# Adjusting the Coolant Pipe Position

## TSB-20-089 FTL

► eCascadia

Location of the Bolt to Adjust the Coolant Pipe Position

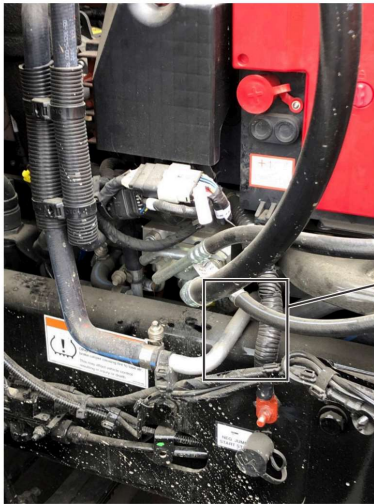
5.  Loosen the bolt and lift up the coolant pipe. See figure [3](#).

6.  Tighten the bolt 11 lb·ft (15 N·m). See figure [4](#).
